HARTMAN EXTRACTOR
HARTMAN EXTRACTOR

DATE 13-7-36
Lloyd's Register Foundation

W133-0152

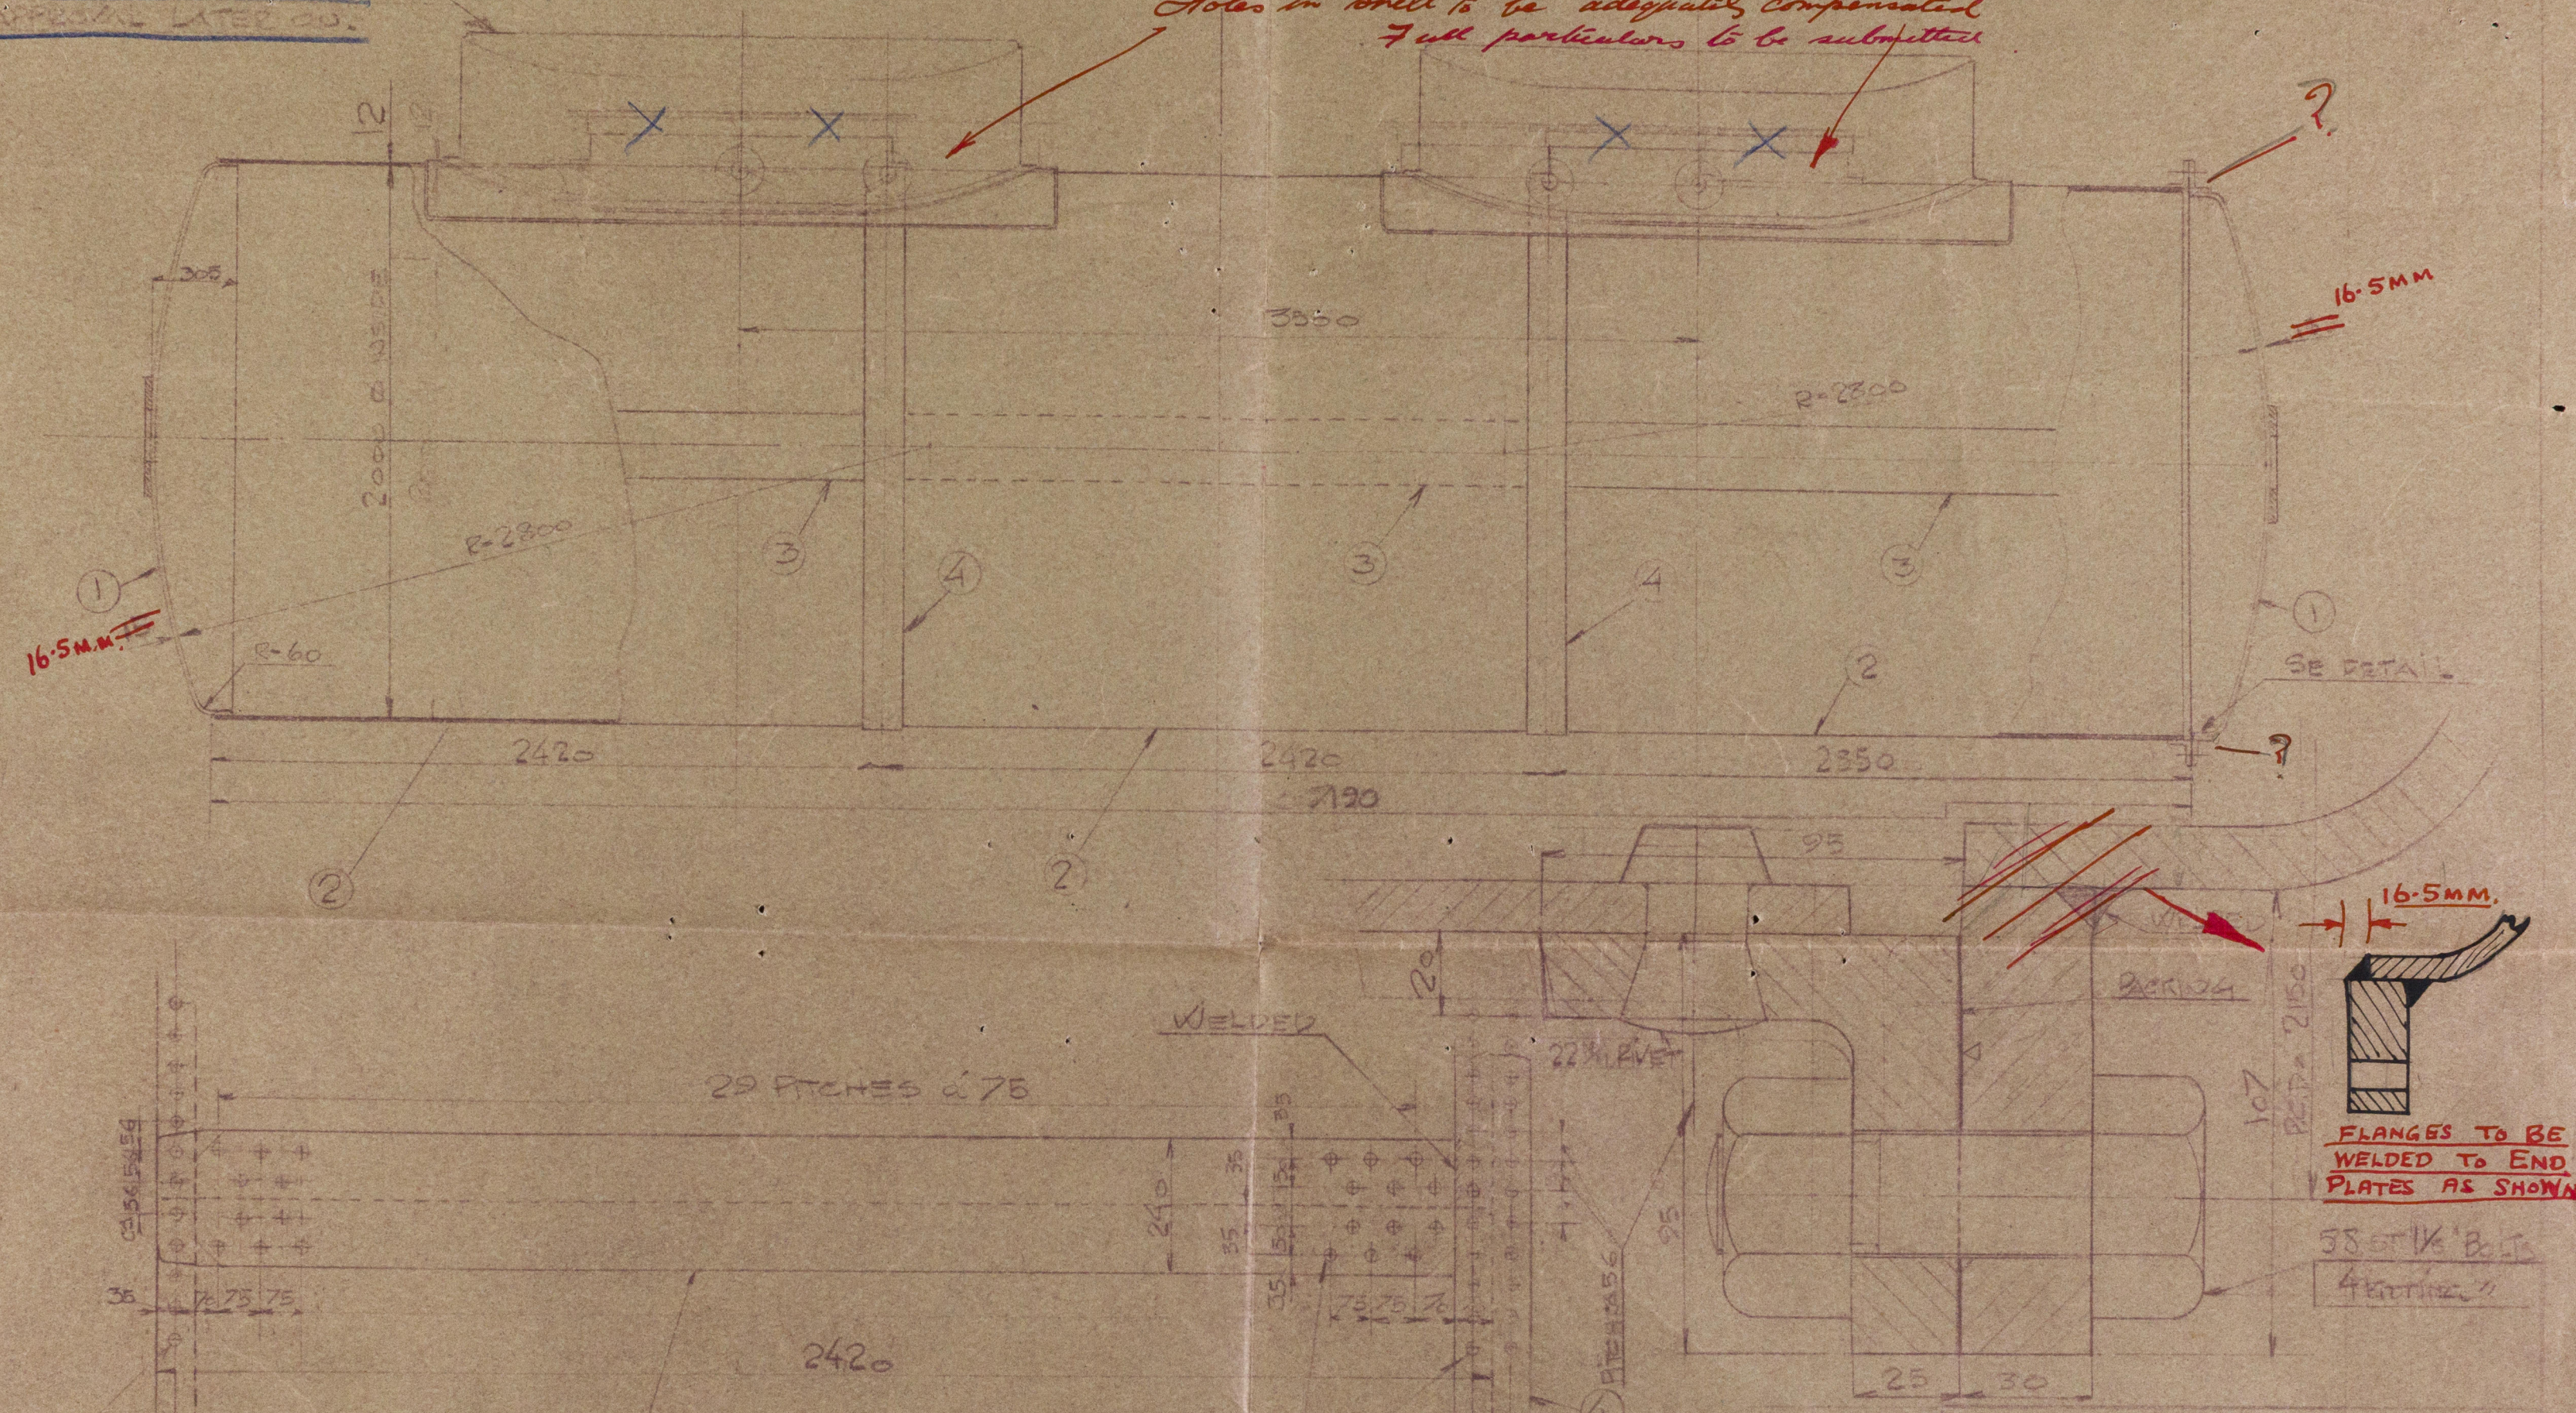
TO BE SUBMITTED FOR
APPROVAL LATER ON.

Holes in shell to be adequately compensated
Full particulars to be submitted
